**GOVERNMENT OF THE DISTRICT OF COLUMBIA
DEPARTMENT OF TRANSPORTATION**

MEMORANDUM

SUBJECT: BZA Case No. 19452 - 1700 Rhode Island Ave NE - Ward 5 Emergency Shelter

Figure 1 - Site Access (Source: Gorove/Slade)

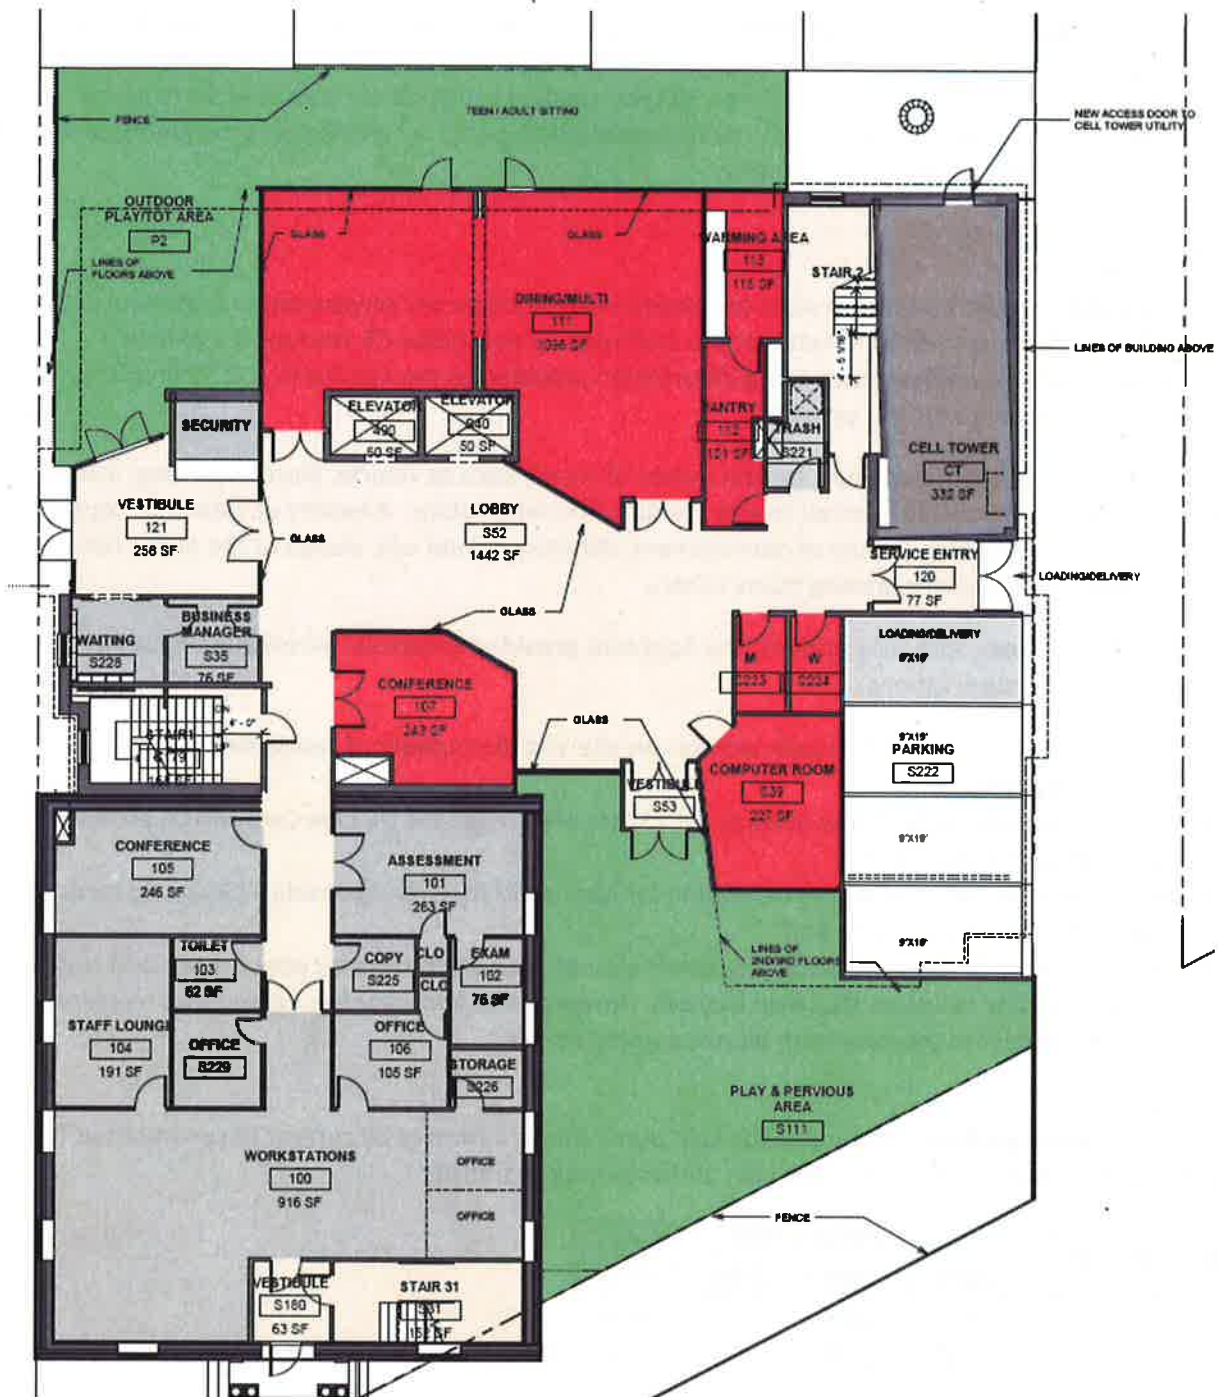
The site is located on an improved lot bounded by 17th Street to the west, Rhode Island Avenue to the south, a public alley to the east, and residential properties to the north. The Applicant proposes to utilize the public alley for parking and loading access. The pedestrian access for the shelter is from 17th Street and Rhode Island Avenue via accessible paths. Vehicular parking and loading access will occur from the public alley to the east.

The Applicant proposes one 19-foot service/delivery space in lieu of the zoning requirements for one 30-foot loading berth and one service/delivery space. The Applicant confirmed that all food and supply delivery will occur from vehicles no larger than 19-feet. Loading activities will consist of six to seven deliveries per day, including trash pick-up. The proposed loading area is sufficient to accommodate the project and is consistent with DDOT standards.

Figure 3 - On-Street Parking Occupancy – 10 PM (Source: Gorove/Slade)

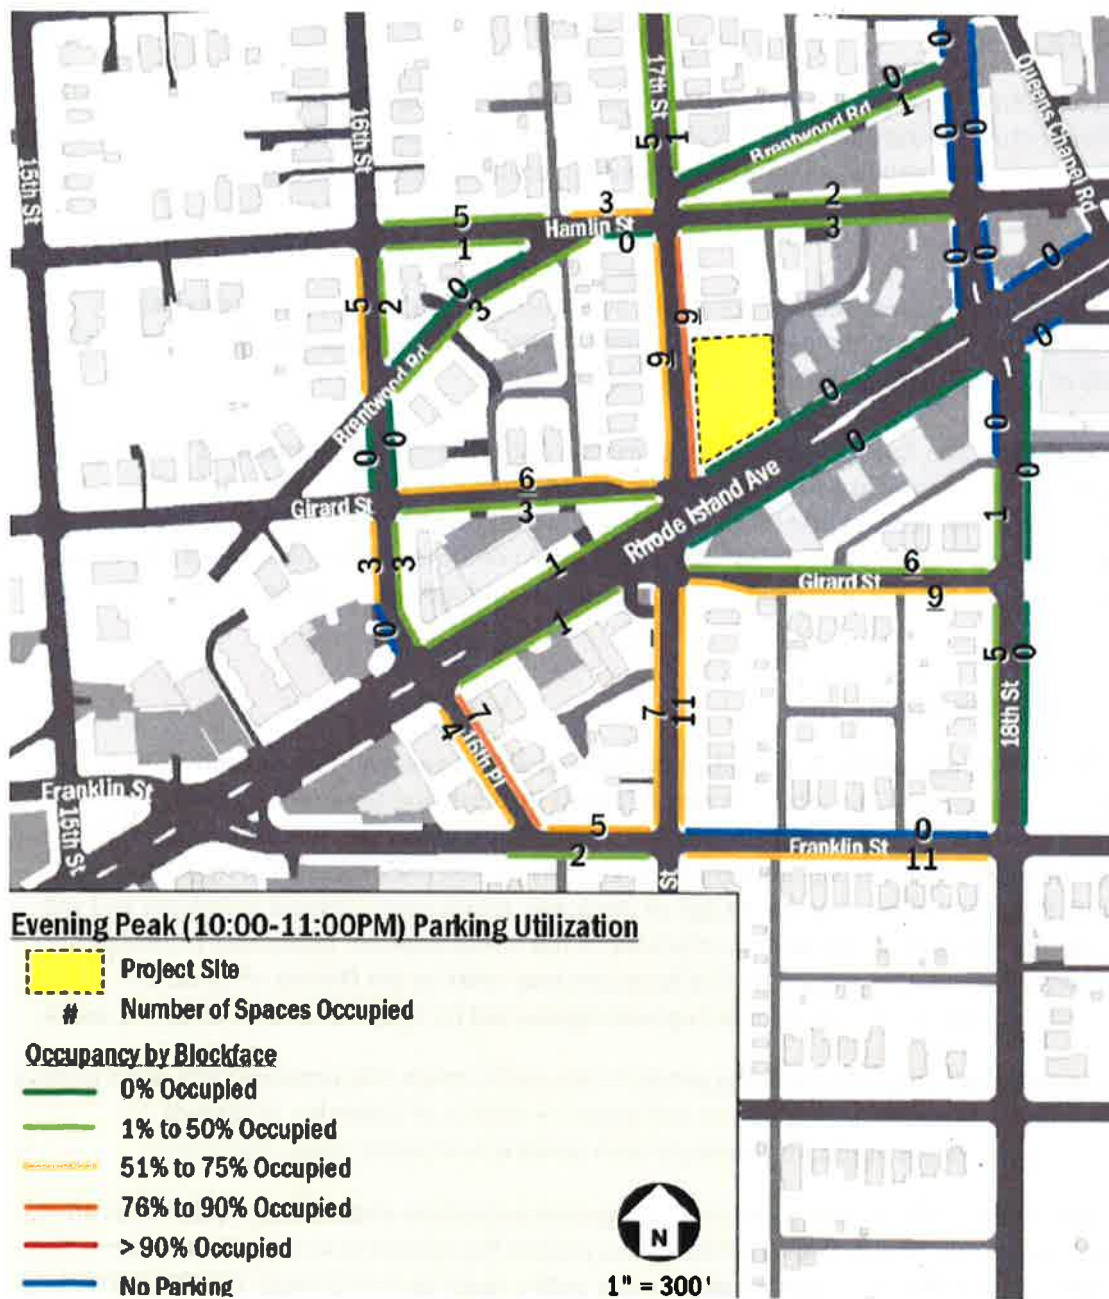
The Applicant performed a parking occupancy study on Wednesday, December 7, 2016, to determine if the surrounding street network has the capacity to meet parking demand. The study was conducted within a quarter-mile of the site, at hourly intervals from 5:00 pm to 12:00 am. The study shows that during 10:00 pm when peak occupancy was observed, there are approximately 243 available on-street parking spaces out of 377 spaces. The study concluded that the on-street parking supply has the capacity to meet parking demands generated by the staff use.
